SURFACE WATER DRAINAGE CALCULATIONS

BARLOW MOOR CENTRE

BOS2 MANCHESTER LIMITED

Project No.: 10607				
Issue Date	Revision	Status	Issued By	Checked By
01.03.2022	01		S Dop	E Jones

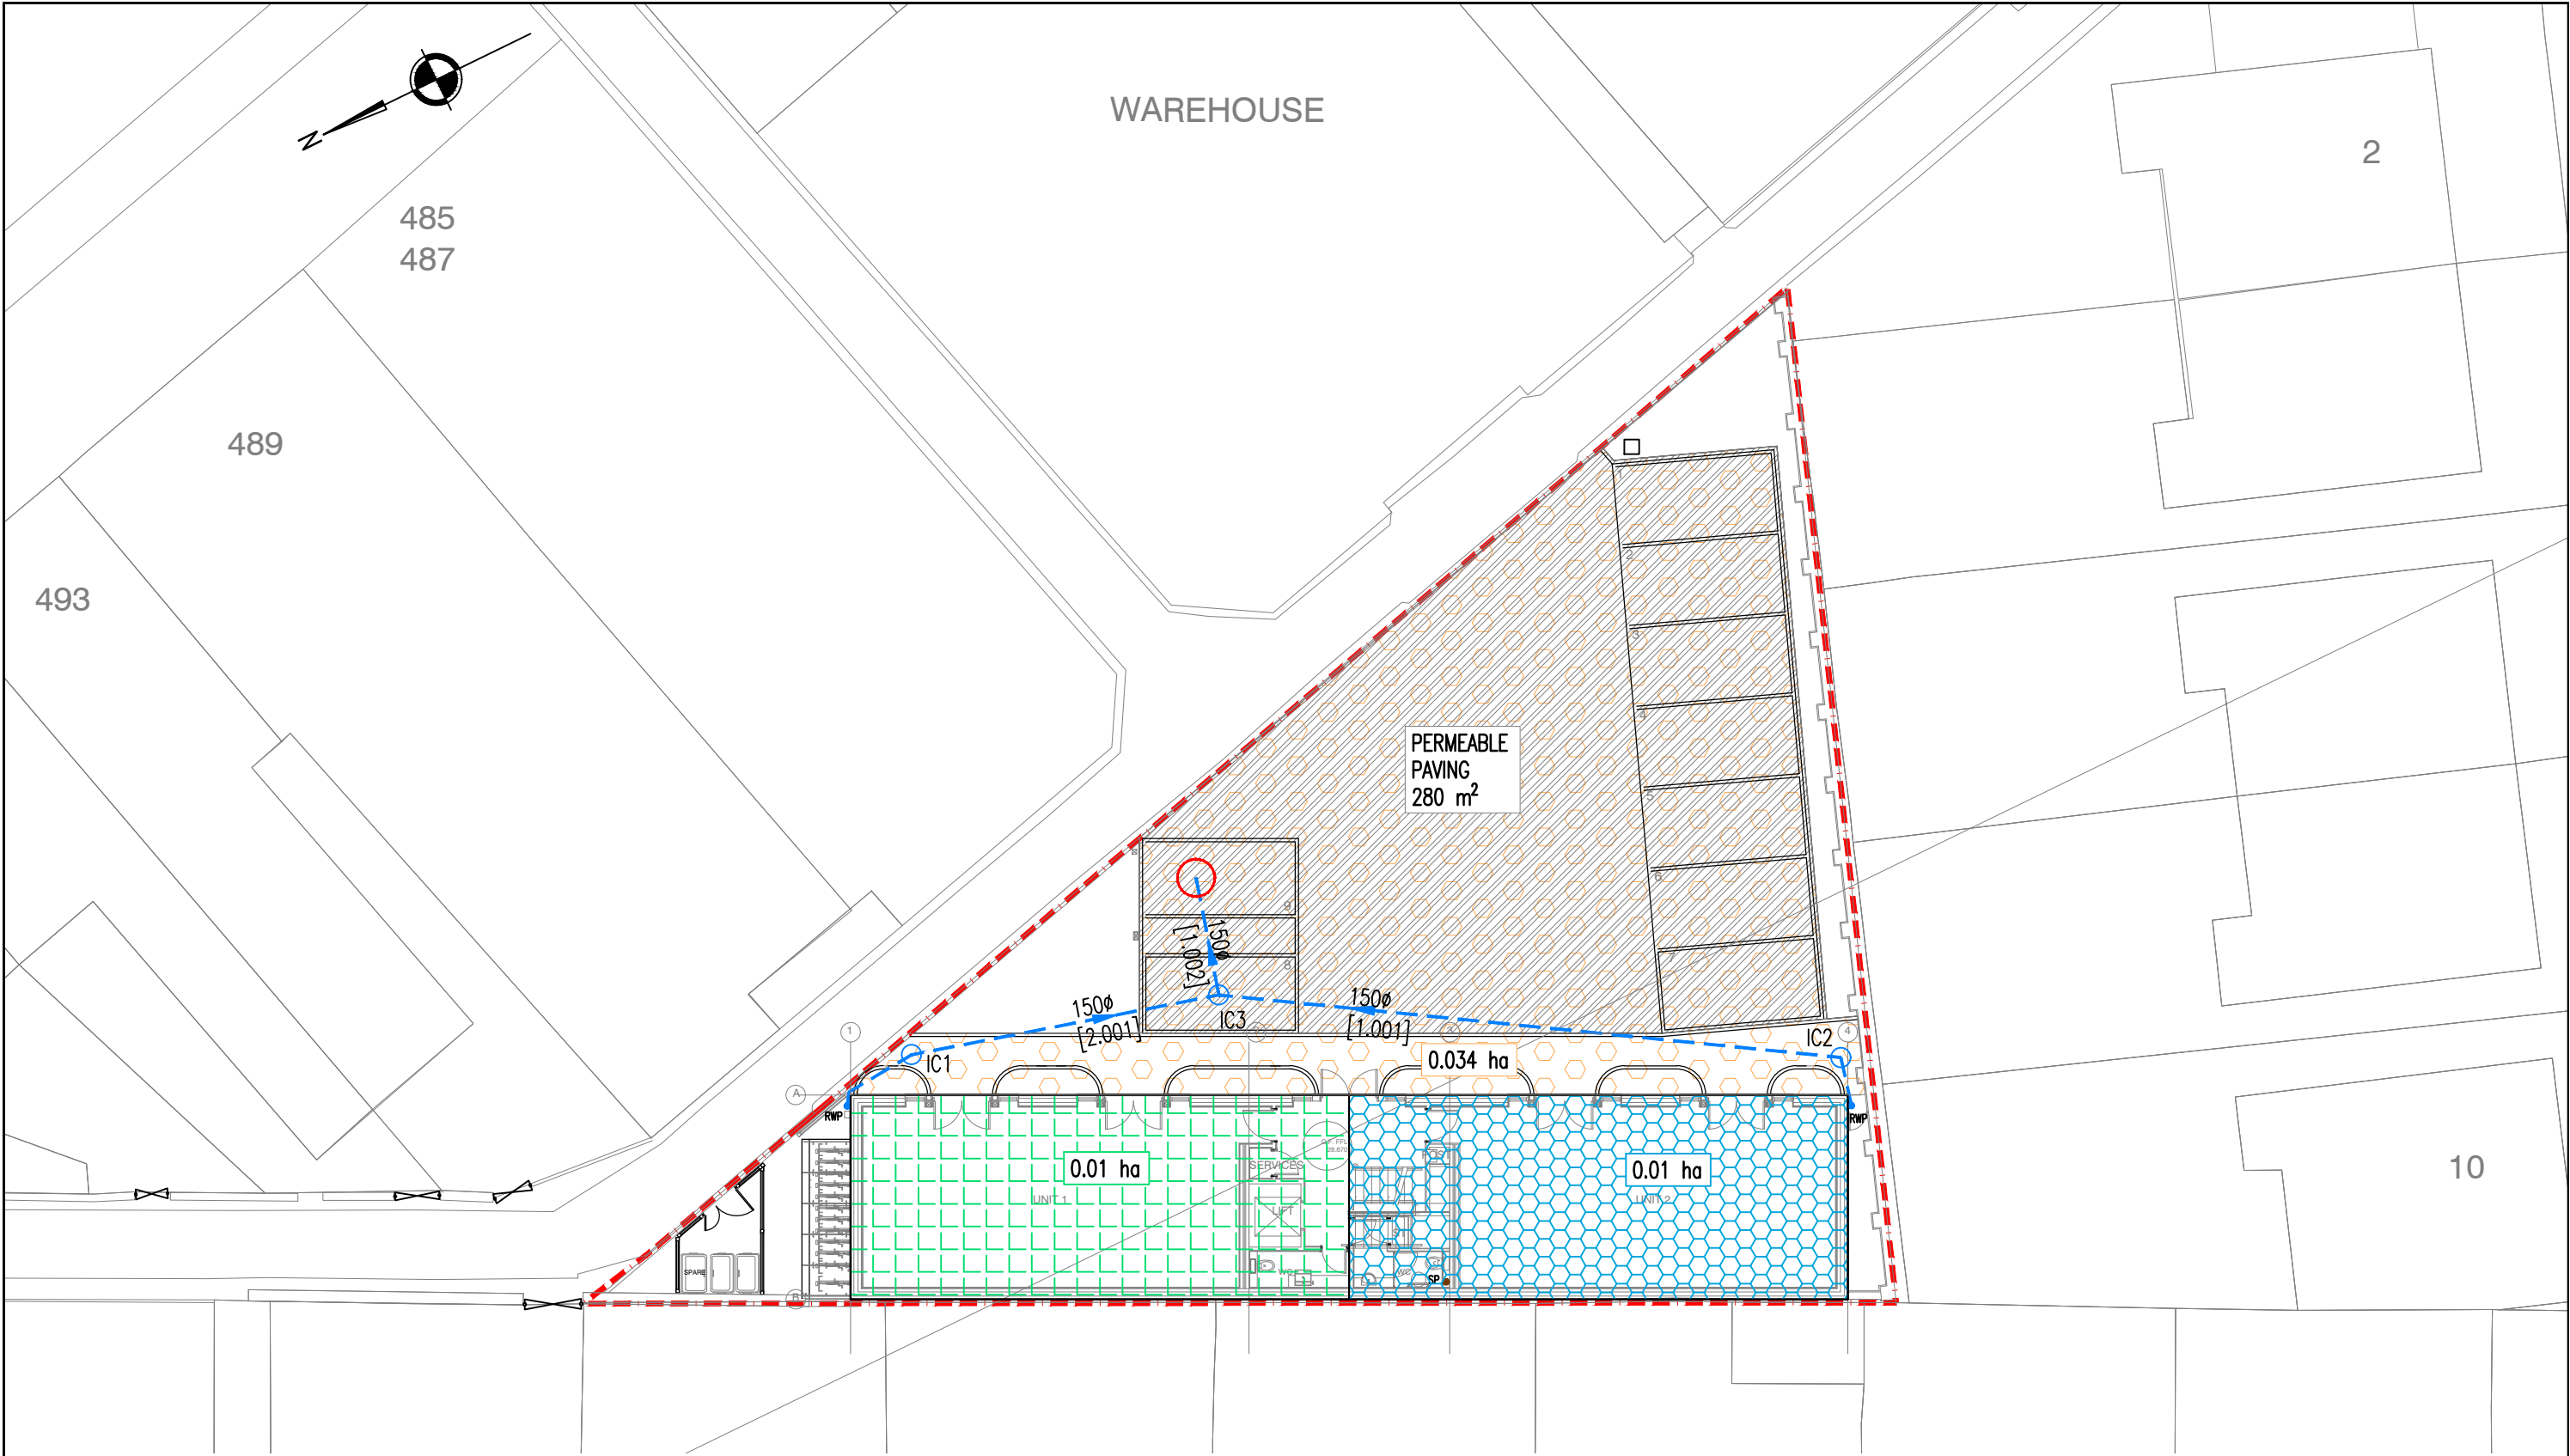
- Details of how the scheme complies with Non-Statutory Technical Standards for SuDS. This should account for the 30 year and 100 year storms (see S7, S8, S9 of the standards) and will need hydraulic calculations to support this.*
- Details of how the proposed discharge rate achieves compliance with the Local Flood Risk Management Strategy: "A 50% runoff rate reduction for Brownfield sites, with an aim of reducing runoff to Greenfield rates up to a 1 in 100 year storm event, including consideration of climate change".*
- Please present evidence of acceptance of rate/connection point from United Utilities.*
- Permeable paving is acceptable due to the statement that soil and groundwater sampling of the sub-strata indicated no impact on human health and controlled waters.*

- Further to our review of the submitted documents, DRAINAGE STATEMENT, Ref 10607 Barlow Moor Centre - Dated 16 November 2021, United Utilities recommends that condition 16 is not discharged. This is because although infiltration has been proven to be feasible, soakaways have not been utilised in the drainage plan. The drainage strategy does not confirm whether or not soakaways would be allowed by the EA in made grade. We would request confirmation of this.*
- Finally, the drainage strategy does not state the cover and invert levels of the manholes on site. We request an amended plan detailing these in metres AOD in order to determine the risk of surcharge or whether it is at risk of creating a new hydraulic low in our sewer network.*

These calculations and the updated drawing 10607-401 P5, seek to address the above issues.

The surface water design has been amended to discharge all rainwater falling on the site to ground. It is proposed that rainwater pipes discharge into the permeable pavement sub-base, with a depth of sub-base provided to cater for storage for the 30 year and 100 year storms. This is in compliance with Non-Statutory Technical Standards for SuDS.

A notional drainage network has been analysed, with roof runoff from an area of 0.02 ha fed into the permeably paved car park area. Larger proposed planted areas and minor areas of remote permeable paving have been excluded (indicated on 10607-SK01). Calculations have been undertaken for a 30 year storm with 20% climate change applied and a 100 year storm with 40% climate change. The previously established infiltration rate of 2.2×10^{-5} m/s has been applied.
